PROJECT
 P35B6 - EVANSTON K-4

TITLE
 OVERALL SITE PLAN

Proposed Changes:
 1. Moved building on-site ~2.5m closer to the western property line. Through detailed design development the building was shifted to accommodate better cut/fill and room for the potential future portables on the east of site. These portables are not in contract at this moment and would be added through a separate DP/BP in the future. Shifting the building accommodates future flexibility for this potential project.
 2. Deleted additional mechanical room. Through detailed design development the 2 original proposed mechanical rooms were consolidated into 1 mechanical room.

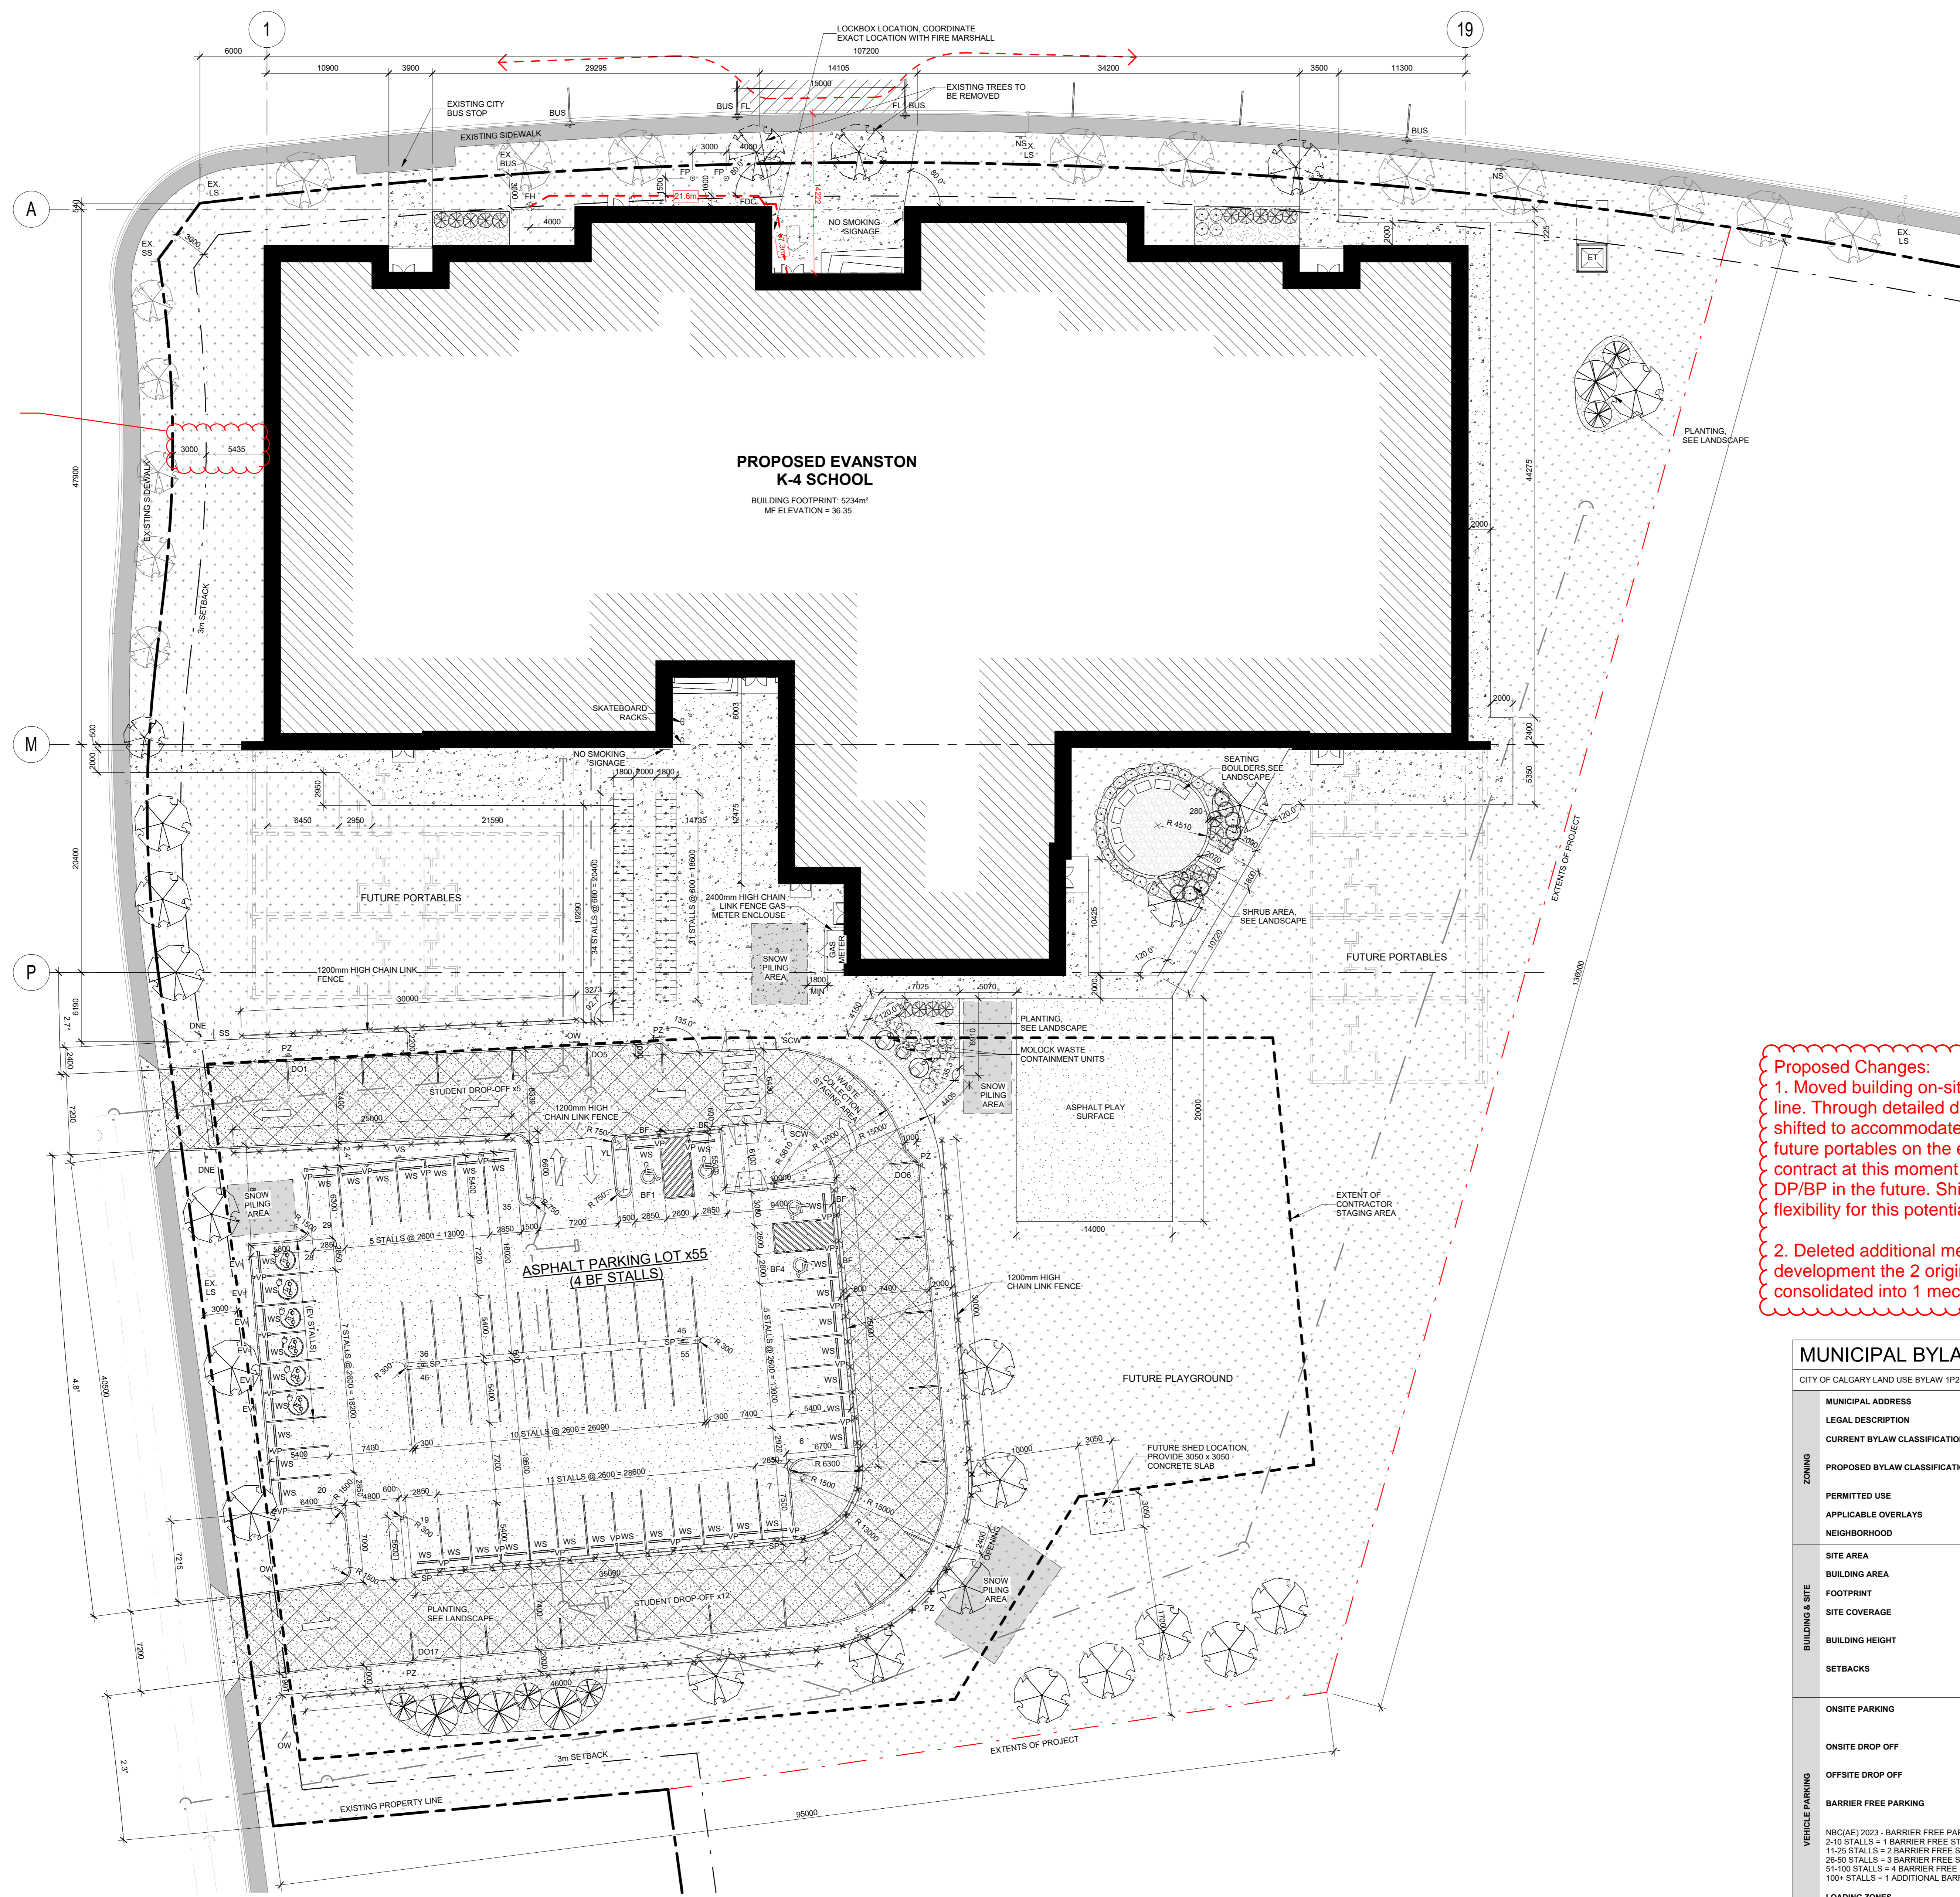
1. Moved closer to property line.

Proposed Changes:
 1. Moved building on-site ~2.5m closer to the western property line. Through detailed design development the building was shifted to accommodate better cut/fill and room for the potential future portables on the east of site. These portables are not in contract at this moment and would be added through a separate DP/BP in the future. Shifting the building accommodates future flexibility for this potential project.
 2. Deleted additional mechanical room. Through detailed design development the 2 original proposed mechanical rooms were consolidated into 1 mechanical room.
